Design Refinements

THE TIMBERYARDS BY RTL CO.

Precinct Wide and Building Design Refinements

Approved SSDA - DA-110-007_ Ground Level - Victoria Road

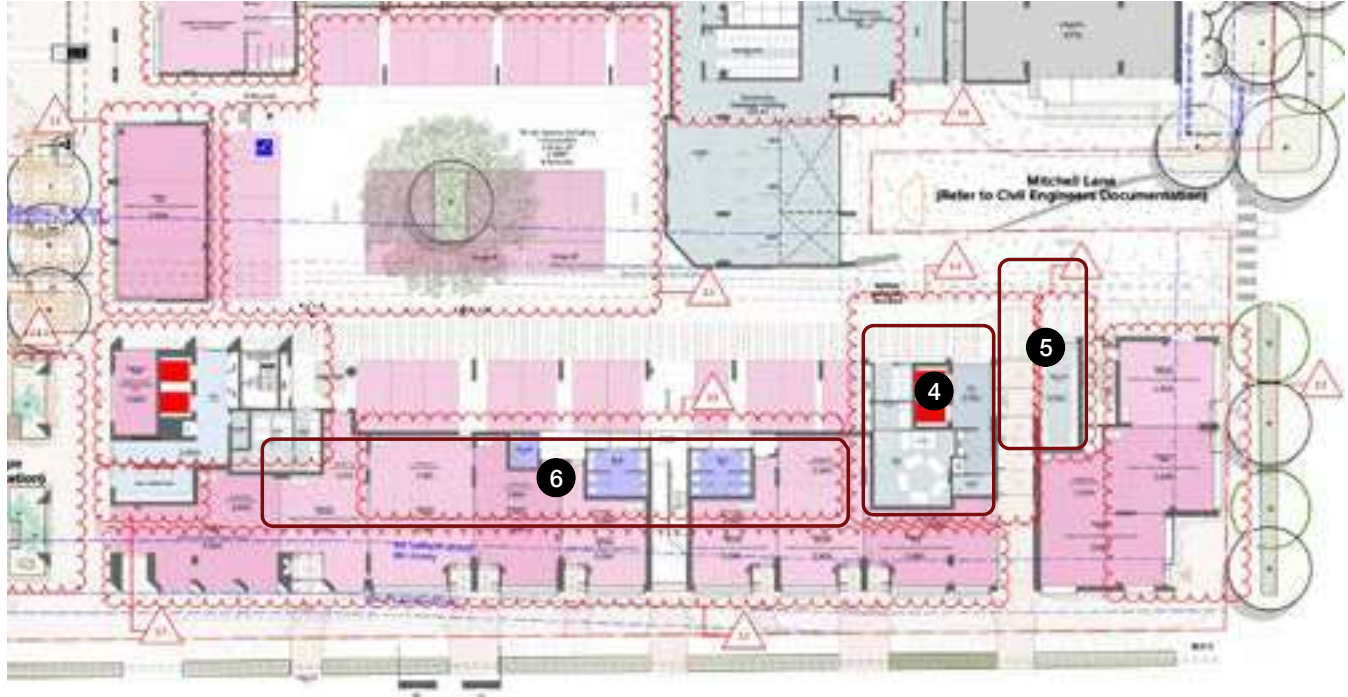
Foyer & Retail Refinements
The C1 lobby area has had minor refinements to provide access via a new through site link, improving flexibility of entry and exit across the site. This also enables a dedicated mail room,
- 5

Loading Dock
The relocation of the Building C loading dock has opened up the ability to create a through site link, as well as accommodate a building specific mailroom in line with the revised site wide mail strategy. Building C dock provisions have been absorbed by Building B.
- 6

Victoria Rd Back of House
Continued consultant advice has driven minor refinements to planning levels throughout the Victoria Road retail, with a strategy established to lift BOH areas above the required flood planning level. These levels now align with the Mitchell Lane carpark entry.
